MODIFICATION SHEET NO. RDSO/2015/EL/MS/0437, Rev.'0' Dated 06.01.2015

Modification sheet to avoid failure of temperature sensors due to increase in resistance value of temperature sensor cable shielding.

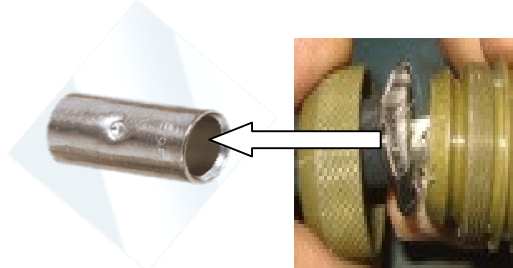
Presently, in three phase locomotives temperature sensor cable has been provided between TM temperature sensors and D slot card in SR control electronics rack in two parts. In 1st part, cable is provided between SR control electronics and Junction box and in 2nd part, cable is provided between junction box to TM temperature sensor. Proper earthing of shielding is provided on the sub-D side with body in 1st part however shielding on male connector side towards junction box has been provided by simply trapping the shielding wire between ferrule and end bell. In 2nd part, shielding on female connector ends i.e. towards junction box side is provided by simply trapping the shielding wire between ferrule and end bell however on cable fitting TM sensor side, it is provided by clamping module for shielding. It is observed that after a year or two, resistance value of temperature sensor shielding on connector side increases due to looseness of gripping between connector ferrule and end bell causing Loco failure due to Error P.S. Hardware. It has also been noticed that the shielding on cable fitting PG-16 side has not been done properly during manufacturing at CLW. It has been noted that sometimes pin-E of female and male connector at junction box side left blank and physically no pin on 'E' position has been provided which lead to non earthing of shielding throughout the length of cable. This issue was discussed in 36th MSG meeting held at Nasik as item 2 (New Items). As per decision of MSG recommendation shielding wire should be connected to pin E of the female and male connector in Junction box side and on the traction motor side it should be connected to the gland. CLW to amend specification suitably so that in new supply proper shielding and earthing is provided from supplier's end. In existing arrangement, suitable instructions are required to be issued by RDSO. This modification sheet is being issued in compliance of above.

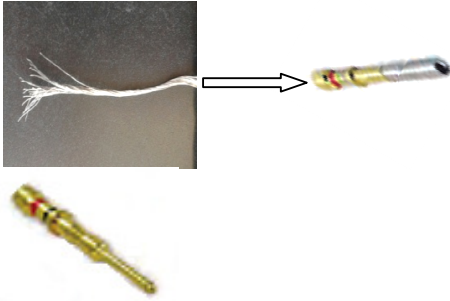
3.0 **Existing Arrangement with cross-references of respective design document:**
 In the existing arrangement, there are two deficiencies due to which proper earthing of shielding are not taking place. The details are as follows:

3.1 Proper earthing of shield wire has not been done at Junction box in both male and female connectors. In some cases earthing has been done however in some connectors (Both male and female), pin E has not been provided in male or female connector or both so that earthing of shield is not ensured throughout the length of cable from Sub-D up to temperature sensor. In some connectors, pin E is provided but not connected to shielding wire.

3.2 Proper earthing of shield wire has not been done at temperature sensor side.

4.0 **Modified Arrangement to replace existing arrangement as given above in 3.0:** In the modified arrangement, the deficiencies given above needs to be addressed.

Case-1: Proper earthing of shield wire has not been done at Junction box in both male and female connectors however Pin E is provided. Ensure that pin E is earthed to body of connector by checking continuity between pin E and connector (male/female) body. If there is no continuity exists that means pin E is not connected to shield wire and earth. In some connectors (Both male and female), pin E has not been provided in male or female connector or both. In both cases following modification needs to be done:

S.No.	Instruction	Picture
1	Cut the existing heat shrinkable sleeve of male/female connector at Junction box side.	
2	Open the end bell of male/female and shielding Wire wrapped together.	
3	Insert wrapped shielding wire into one end of 1 sq. mm 2cm long copper tube butt connector and crimp the wrapped wire.	
4	Take wrapped shielding wire of 1 sq.mm and adequate length separately whose one end reach up to female/male pin of connector and put other end into copper tube butt connector inside approximately 1cm and crimp the wrapped wire at copper tube butt connector.

5	Crimp other end of separately taken wrapped shielding wire as per 4 above on male or female pin or both as the case may be.	
6	Insert the 1.2 mm dia. heat shrinkable sleeve approximate 28mm length for covering the wrapped shielding wire and Shrink the sleeve with the help of heat gun.	
7	Insert the pin in to E' position of the male/female connector.	
7	Close the end bell.	
8	Cover the female/male connector with heat shrinkable sleeve "preform shrink part GR18"	
9	Shrink the sleeve with the help of heat gun.
